Southern Colorado Rail Park

Conceptual Drainage Summary

September 2023

M&S CIVIL CONSULTANTS, INC.
212 N. Wahsatch Avenue
SUITE 305
COLORADO SPRINGS, COLORADO 80903
(719) 955-5485

Figure 17. High Capacity Roadway Construction

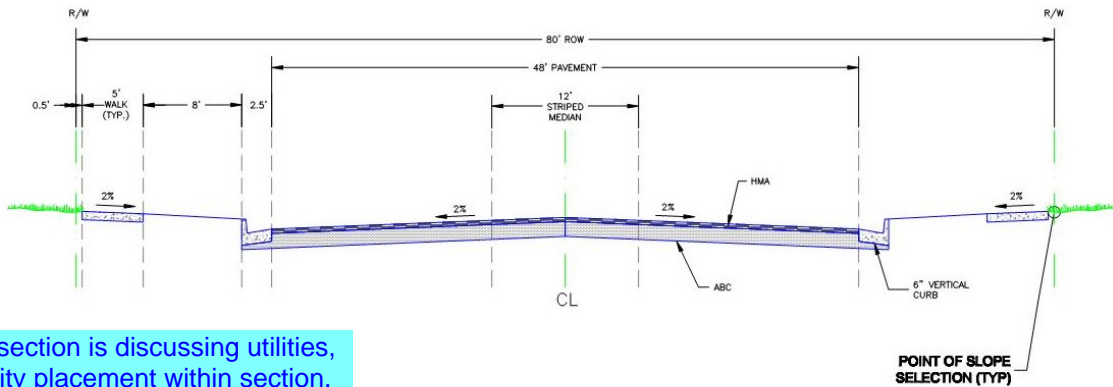
Since this section is discussing utilities, include utility placement within section.
